SSD-87925706

SSD-100293708

300 BURNS BAY ROAD, LANE COVE HDA

WRITTEN SUBMISSION: LETTER OF OBJECTION

89/300A Burns Bay Road Lane Cove

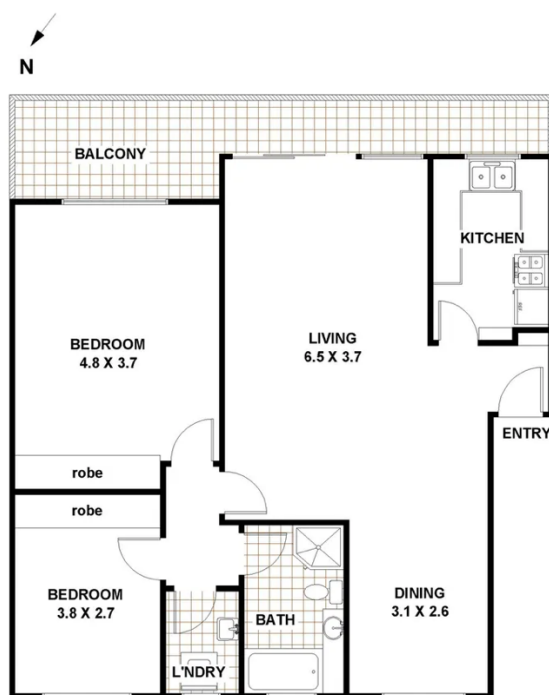
2. DEVASTATING OVERSHADOWING TO 36 UNITS AT 300B BURNS BAY ROAD, including north facing open plan living/dining/study-bed room windows facing north and the subject site:

19/300C Burns Bay Road, Lane Cove

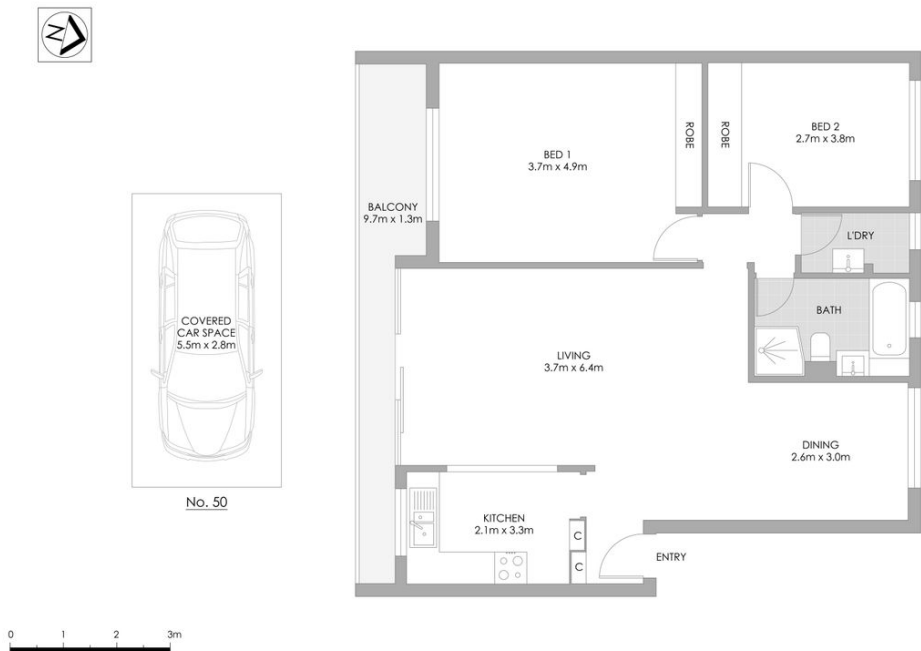
3. DEVASTATING OVERSHADOWING TO 40 UNITS AT 300C BURNS BAY ROAD, including north facing open plan living/dining/kitchen/study windows facing north and the subject site:
- Ground: Units, 1, 2, 11, 12, 21, 22, 31, 32
 - Second: Units 3, 4, 13, 14, 23, 24, 33, 34
 - Third: Units 5, 6, 15, 16, 25, 26, 35, 36
 - Fourth: Units 7, 8, 17, 18, 27, 28, 37, 38
 - Fifth: Units 9, 10, 19, 20, 29, 30, 39, 40
